**DRB ACTIONS**

**PROJECT NAME & NUMBER** MRCD MAP 38, Lot 300  
# 100324A

**CITY OF ALBUQUERQUE  
PLANNING DEPARTMENT  
Development Review Board  
2/18/04 Comments**

**RE: MRGCD MAP 38, Lot 300/sketch**

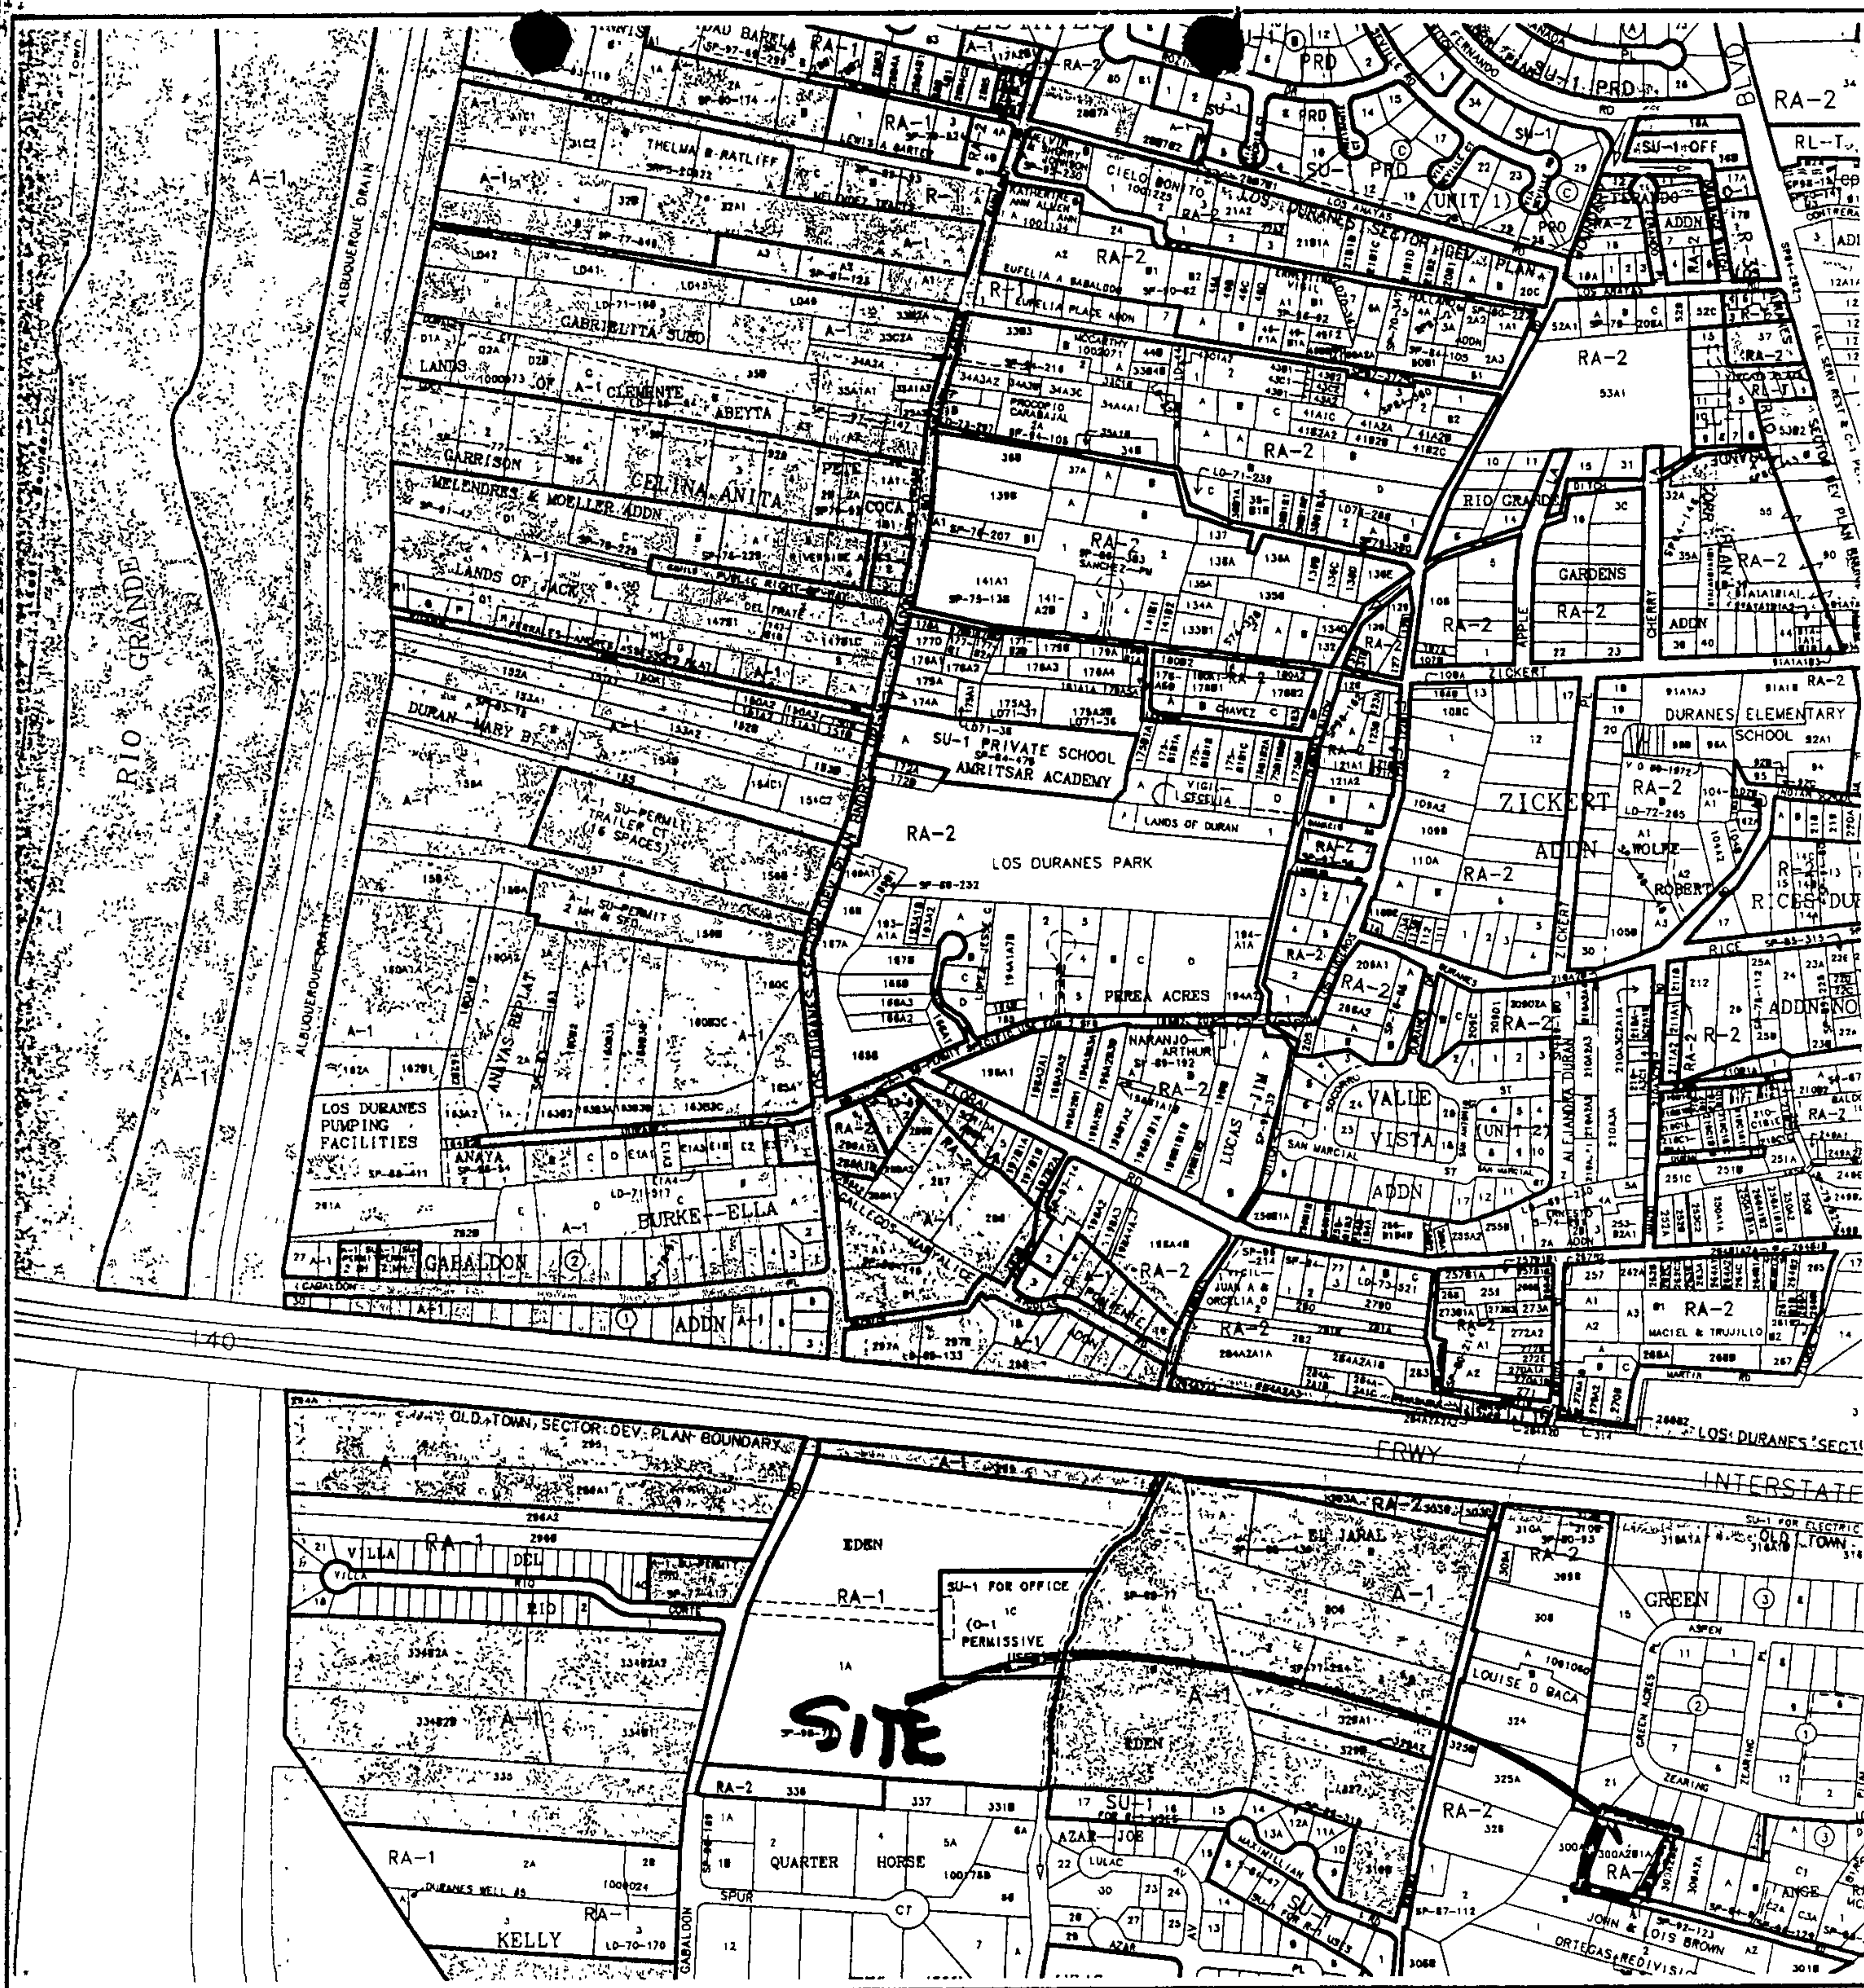
Minimum lot size for RA2 zoning is 10,890 square feet & minimum lot width is 75 feet.  
Setbacks are the same as R-1 zoning except the rear yard setback is 25 feet.

1. Fire protection is limited, so new home construction will be limited to 1530 sq.ft. of total floor area.
2. A fire hydrant is required at the west end of road if one does not already exist.

No.	Comment
①	NEED EXISTING WIDTH OF CARSON ROAD WITH SKETCH OF X-SECTION HOW MANY DWELLINGS USE CARSON ROAD?
②	CUL-DE-SAC REQ'D @ END OF CARSON ROAD
③	PROPOSED LEASUREMENT SHOULD BE 15' MIN. W/ GRAVEL FOR SAME WIDTH
